Attachment II

Marked up copy of R.E. Ginna Nuclear Power Plant  
Technical Specifications

R.E. Ginna Nuclear Power Plant  
Spent Fuel Pool Re-racking Licensing Report  
February 1997

Figure 3.7.13-2  
Fuel Assembly Burnup Limits in Region 2

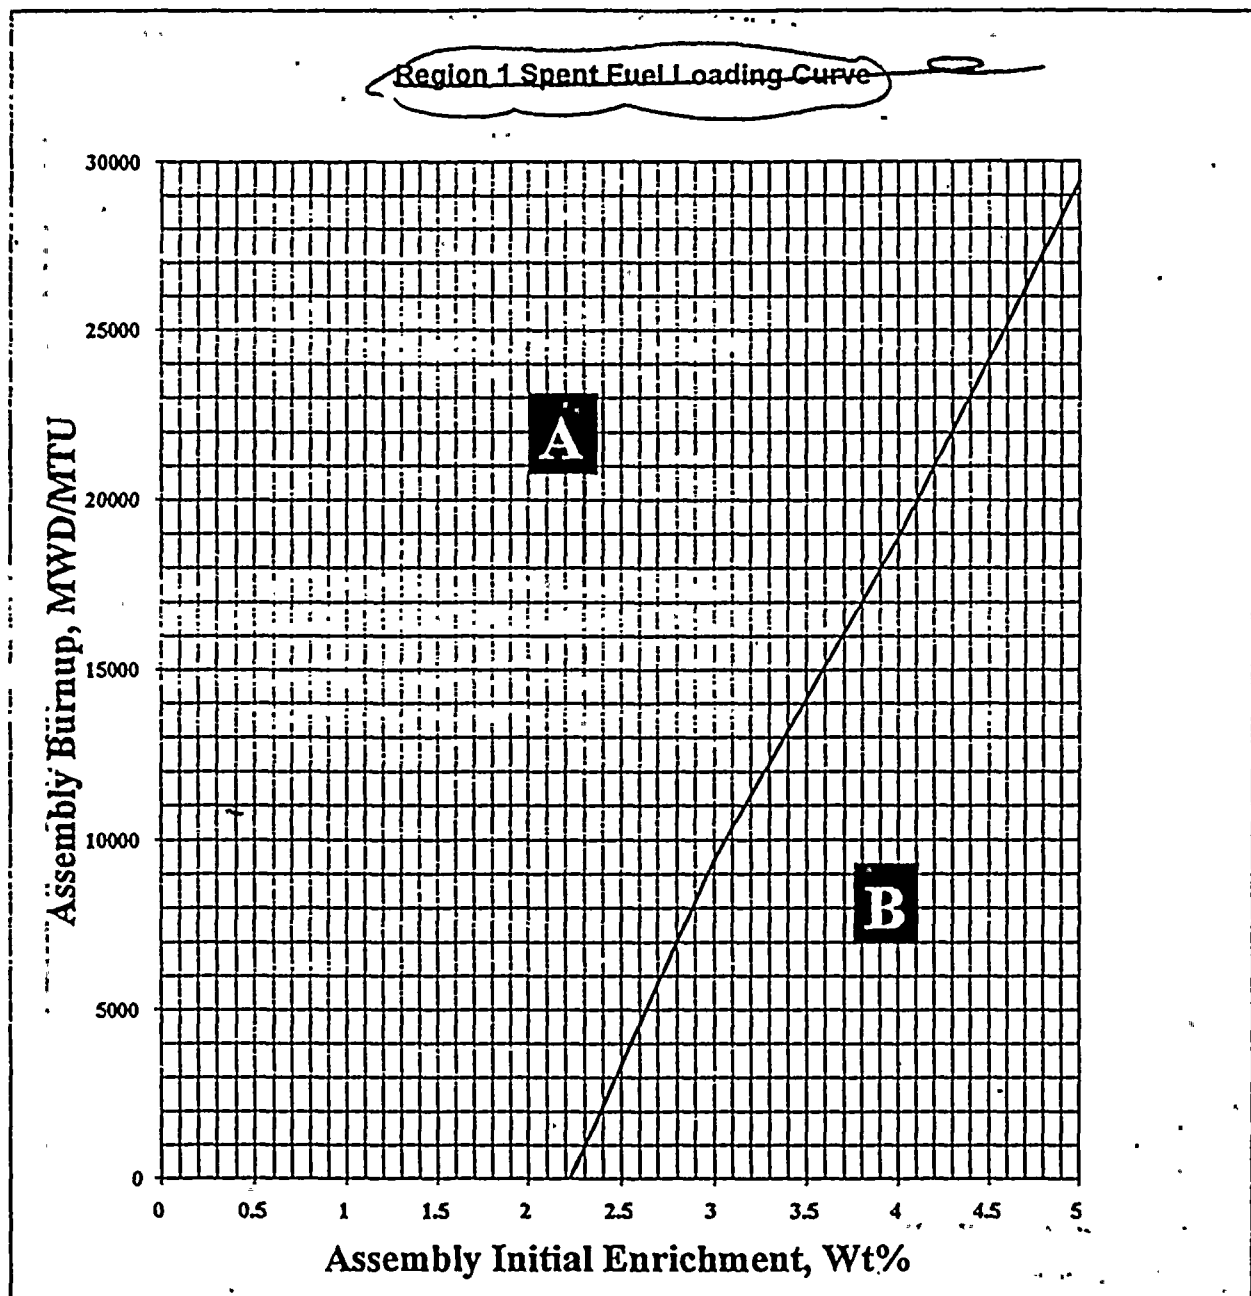
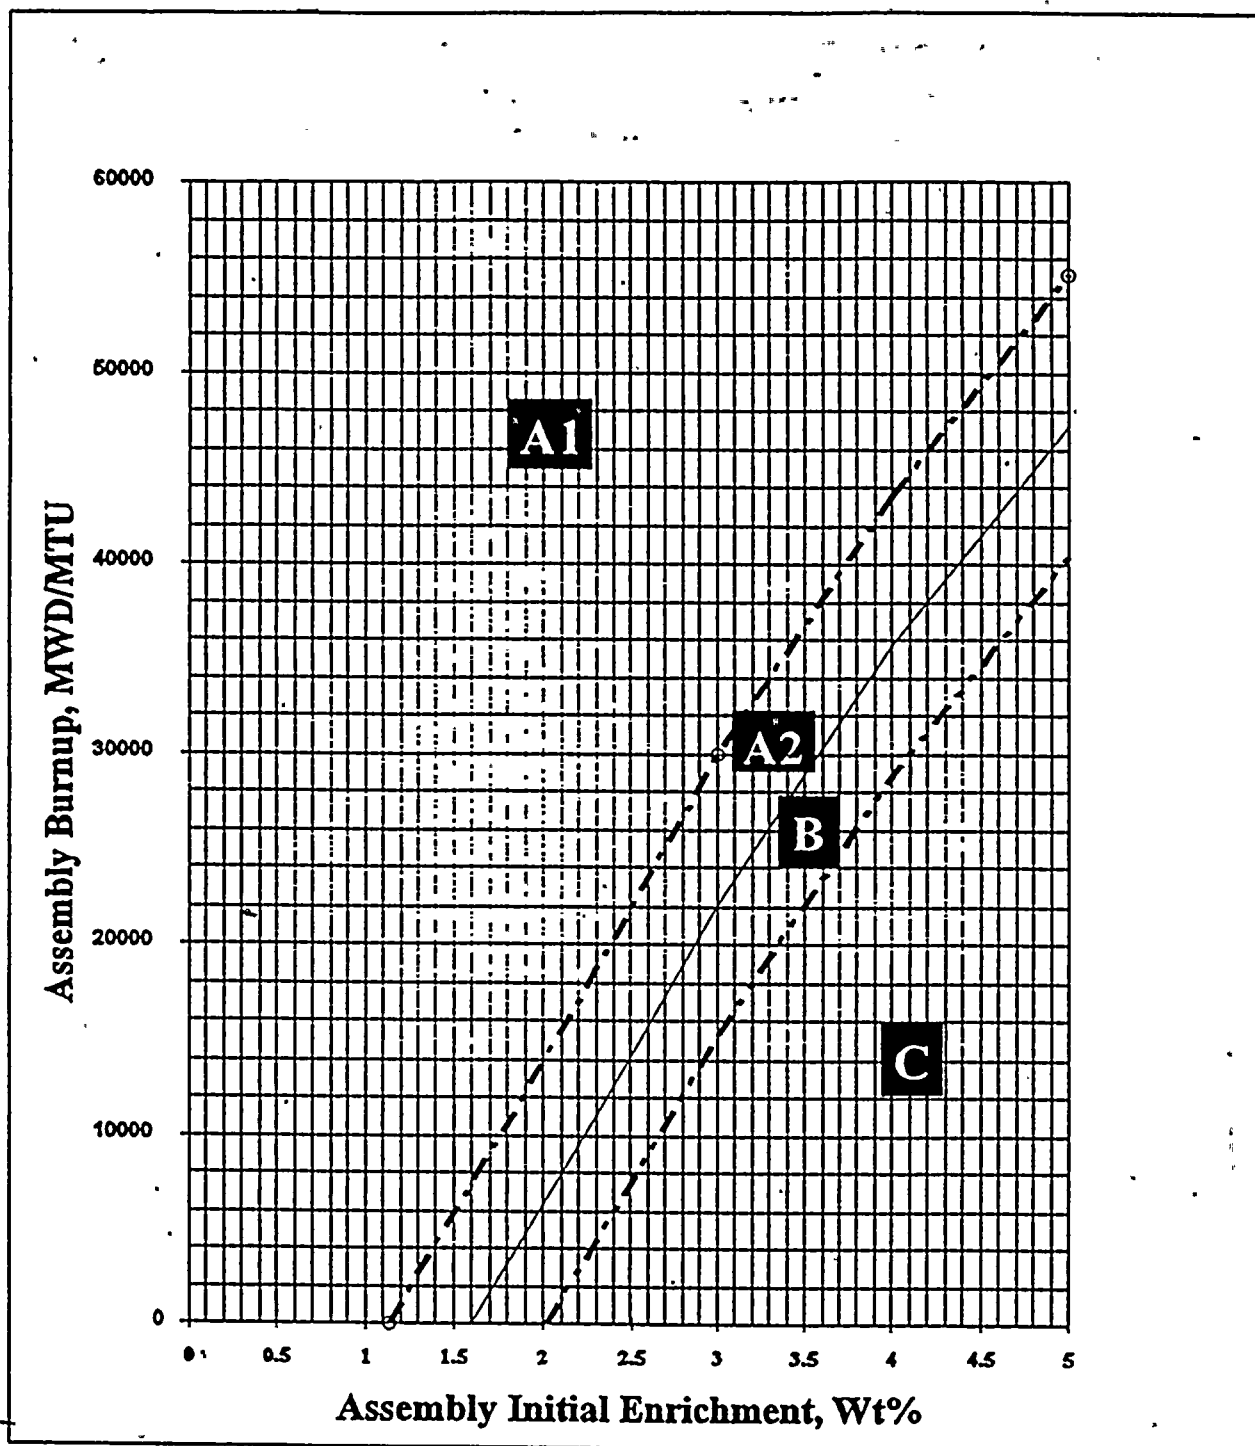
- a. Fuel assemblies in Region 1 shall have a K-infinity of  $\leq 1.458$  and shall have initial enrichment and burnup within the acceptable area of Figure 3.7.13-1; and
- b. Fuel assemblies in Region 2 shall have initial enrichment and burnup within the acceptable area of the Figure 3.7.13-2.

- A1 - Acceptable burnup domain for storage in any location within Region 2.
- A2 - Acceptable burnup domain for storage face-adjacent to a Type A1 or A2 assembly, or a water cell.
- B - Assembly burnup domain for storage face-adjacent to a Type A1 assembly or a water cell.
- C - Acceptable burnup domain for storage face-adjacent to a water cell only.
